Serial No.: 09/121,702

For: HEATING OR AIR CONDITIONING  
SYSTEM FOR A MOTOR VEHICLE

PROPOSED DRAWING AMENDMENT  
FOR EXAMINER'S APPROVAL

#### EXHIBIT A

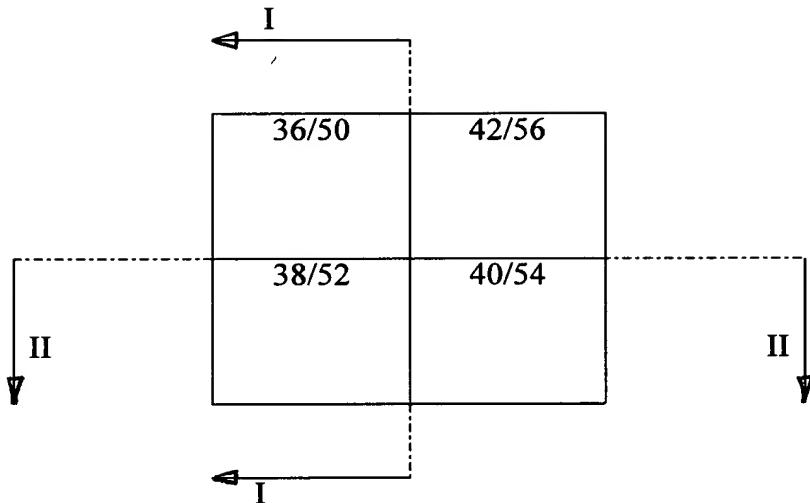
Claims 1-10 were rejected under 35 U.S.C. § 112, first paragraph, because the original specification does not enable one skilled in the art to use and/or make the claimed invention. Applicants again traverse this rejection for the same reasons set forth in the last reply. Applicants submit a schematic illustration (Exhibit A) of the four mixing chambers 50, 52, 54, and 56 and their respective warm-air control elements 36, 38, 40, and 42. The direction of air flow is into the page.

Fig. 1 illustrates the left half (36/50, 38/52) of the housing 12, whereas Fig. 2 illustrates the lower half (38/52, 40/54) of the housing. The examiner is correct that the complete upper half or the complete right half of the housing containing elements 42/56 is not shown. The examiner required applicants to illustrate elements 42/56. In this respect, revised Fig. 3 was submitted, completely illustrating elements 36/50, 38/52, 40/54, and 42/56.

Fig. 1

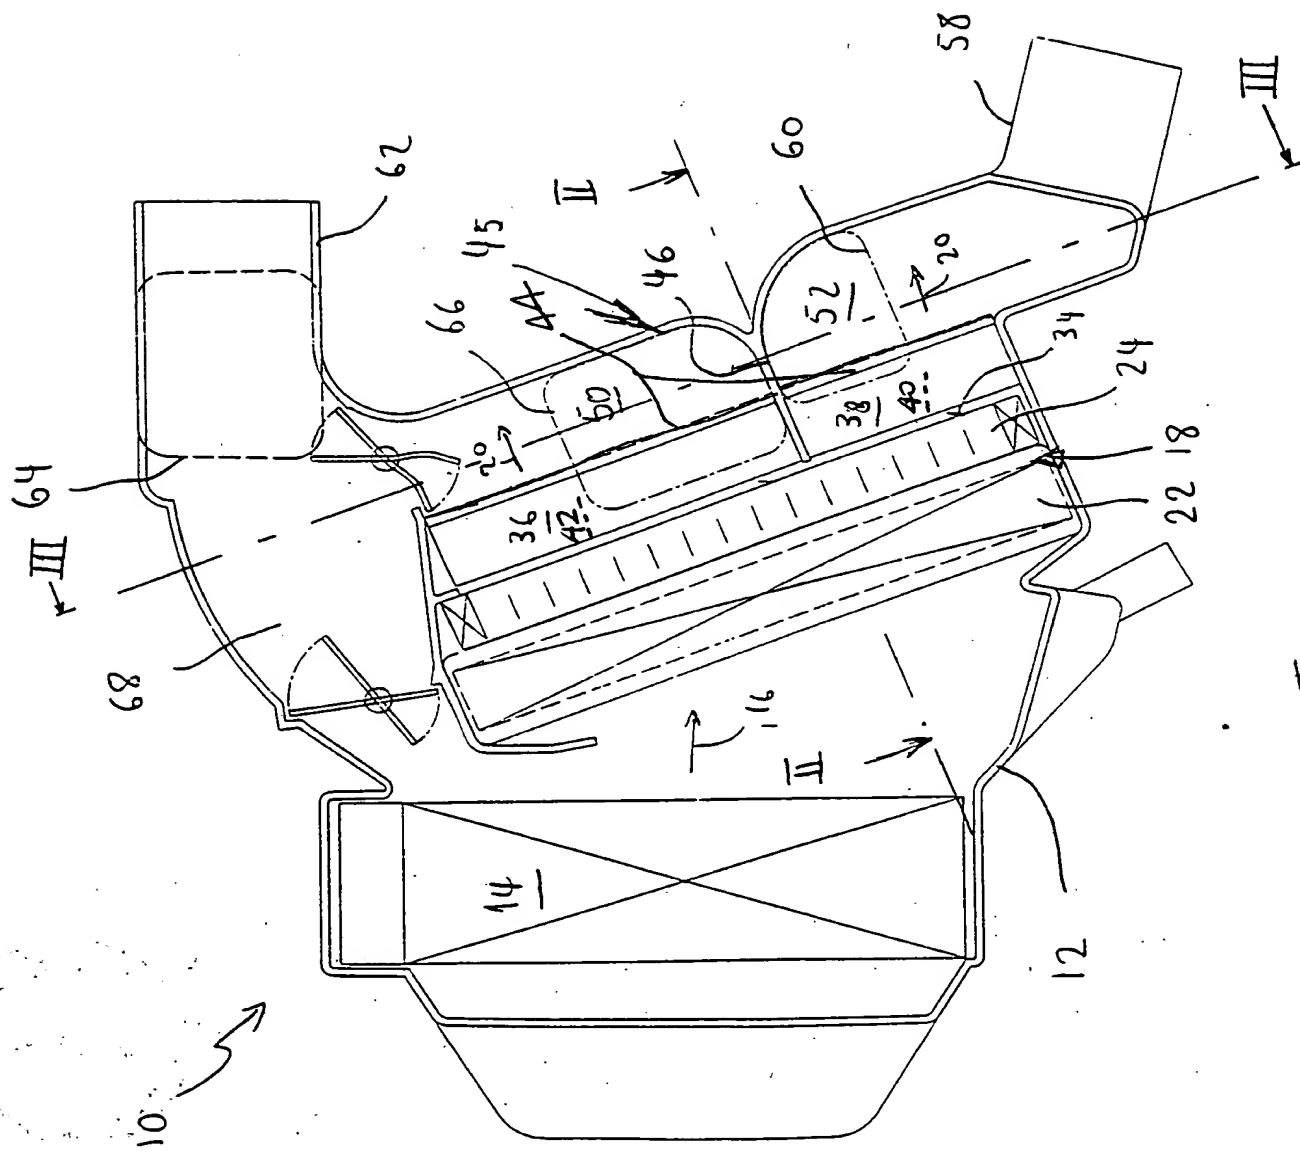
Proposed drawings changes are enclosed. Changes to Figs. 1 and 2 are readily apparent, and thus are not discussed. Changes to Fig. 3 are more complex. Applicants essentially are schematically showing the four heating regions, i.e., warm-air mixing chambers 50, 52, 54, and 56 (clockwise) and the warm-air control elements 40, i.e., a

plurality of lamellae 44, and the flaps 30, 30', 32, and 32', per the examiner's objection to the claims under Rule 83(a).

The drawings submitted in the last reply already incorporate these changes. The examiner, however, objected to Fig. 3 as introducing new matter to which applicants traverse. Fig. 3 is a schematic illustration of the four mixing chambers, 50, 52, 54, and 56. The examiner seems to view that changing the size and disposition of ducts 68, and eliminating parts of the casing, pipes, etc., introduce new matter. These changes do not present new matter because the size and particular geometric configuration, and other extraneous matters illustrated before are irrelevant to the invention being claimed. None of the objected aspects are claimed. The specification has been amended to state that Fig. 3 schematically illustrates the mixing chambers.

Enclosed for the examiner's approval are copies of Figs. 1-3 with red ink markings showing the proposed changes.
